# HISTORIC AND DESIGN REVIEW COMMISSION

**HDRC CASE NO:** 2017-294  
**ADDRESS:** 404 E MISTLETOE  
**LEGAL DESCRIPTION:** NCB 868 BLK LOT 17 & 30 X 50 FT STRIP IN REAR  
**ZONING:** RM-4 H  
**CITY COUNCIL DIST.:** 1  
**APPLICANT:** Lynn Northway Swanson  
**OWNER:** Lynn Northway Swanson  
**TYPE OF WORK:** Installation of relocated 2-story rear accessory structure  
**REQUEST:**

The applicant is requesting a Certificate of Appropriateness for approval to relocate a 2-story rear accessory structure from Houston to the lot of 404 E Mistletoe.

# PLOT PLAN

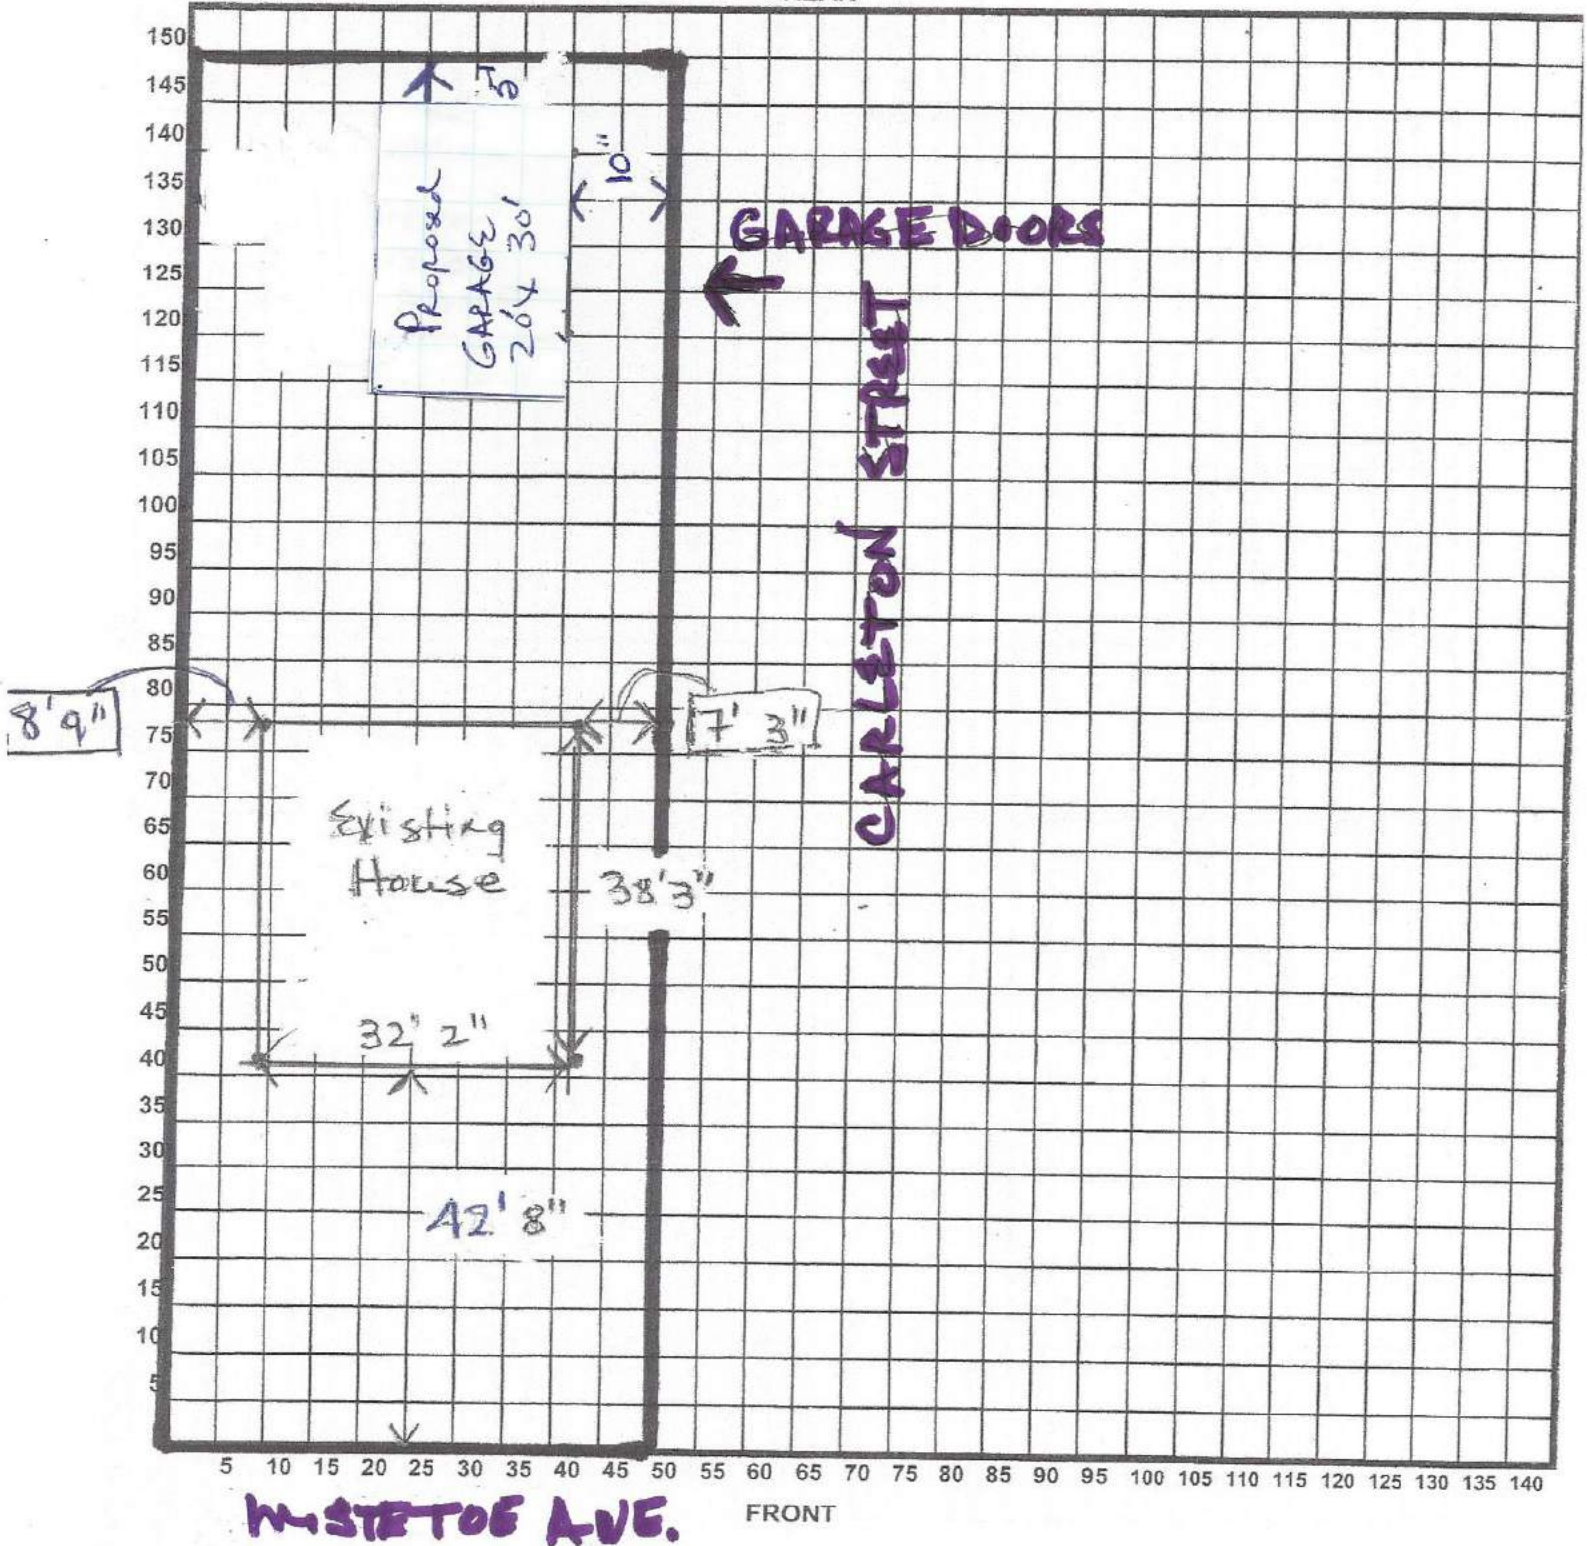
- c. **SETBACK & ORIENTATION** – Per the submitted site plan, the applicant is requesting to orient the garage towards the Carleton right-of-way. The placement strategically avoids existing heritage trees and will not require tree removal. Guidelines 5.B.i and 5.B.ii for new construction stipulate that new garages and outbuildings should follow the historic orientation and setbacks common in the district. Staff finds the proposal for orientation consistent with the Guidelines.

- d. **FOOTPRINT** – The proposed footprint is roughly the same size as the existing primary structure in terms of total square footage. The Historic Design Guidelines for Additions stipulate that new garages and outbuildings should be less than 40% the size of the primary structure in plan. Staff finds the footprint to exceed this percentage. However, historic accessory structures that exceed the 40% stipulation are common in the proposed Tobin Hill North Historic District. Additionally, the structure is a historic garage versus new construction, and dates to the approximate period of the primary structure. Staff finds the proposal consistent with the Guidelines based on these site and district specific considerations.

- i. That the modified height of the structure when placed on the lot be visually subordinate to the existing 2-story home.
- ii. That the applicant submits final construction drawings that indicate any on-site modifications to staff for approval.
- iii. That the applicant meets all setback standards as required by city zoning requirements, and obtains a variance from the Board of Adjustment if applicable.
